To: Bassett Creek Watershed Management Commission
From: Barr Engineering Co.
Subject: Item 5B – Consider Approval of 90% Design Plans for Plymouth Creek Restoration Project, Annapolis Lane through Plymouth Creek Park (CIP 2017 CR-P), Plymouth BCWMC August 17, 2017 Meeting Agenda
Date: August 9, 2017
Project: 23270051 2017 635

5B. Consider Approval of 90% Design Plans for Plymouth Creek Restoration Project, Annapolis Lane through Plymouth Creek Park (CIP 2017CR-P), Plymouth

Basis for Commission Review: 90% plan review

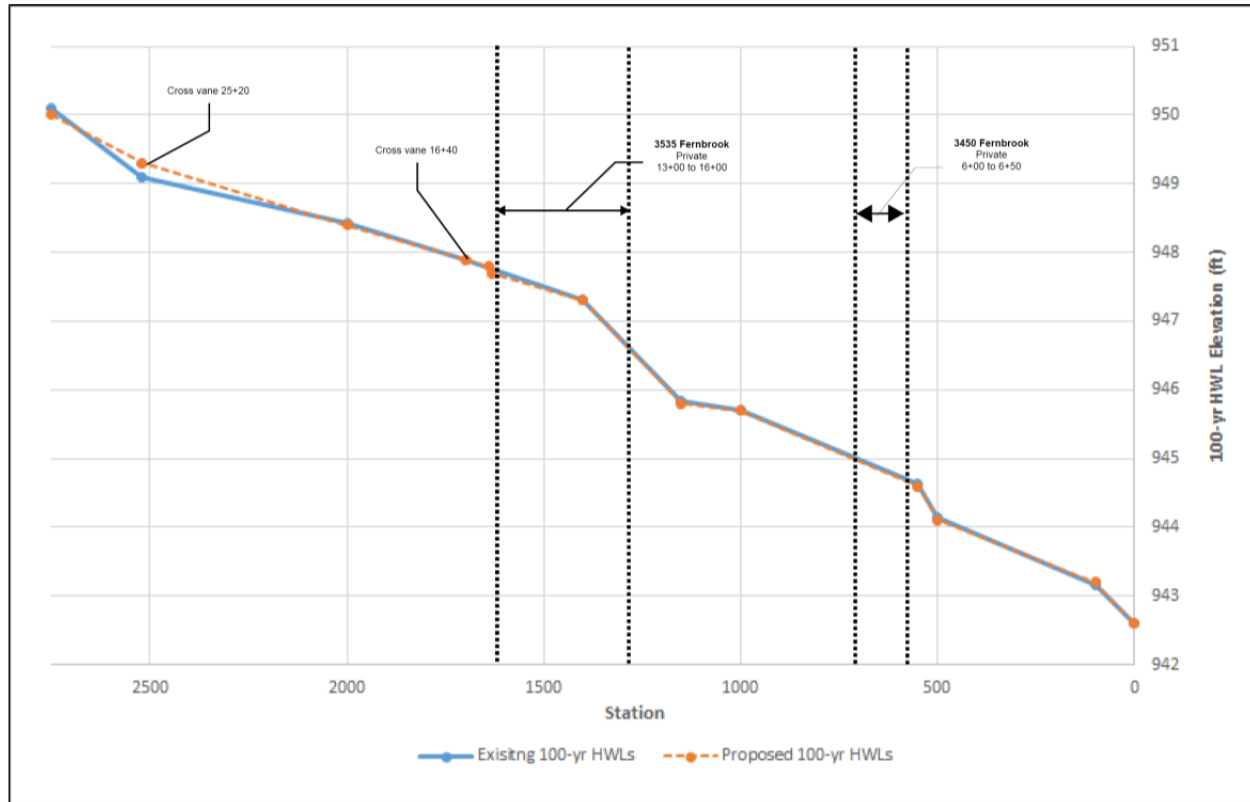
The results still show a 0.2-foot increase in the modeled flood elevation at one cross section on City property within Plymouth Creek Park (Station 25+20). If the Commission does not grant the City's variance request, then the plans must be revised so there is no increase in the modeled flood elevation.

The design plans were revised and the model rerun to show that there will be no increase in the flood level on the private properties at 3535 Fernbrook Lane N and 3450 Fernbrook Lane N. 5 of the 7 cross vanes originally proposed have been replaced with rock check dams. 2 of the 7 cross vanes originally proposed remain at stations 25+20 and 16+40.

The modeling results of the corrected effective XPSWMM model we received from Barr Engineering and updated is shown below. There is no increase in the flood level on the private properties at 3535 Fernbrook Lane N and 3450 Fernbrook Lane N.
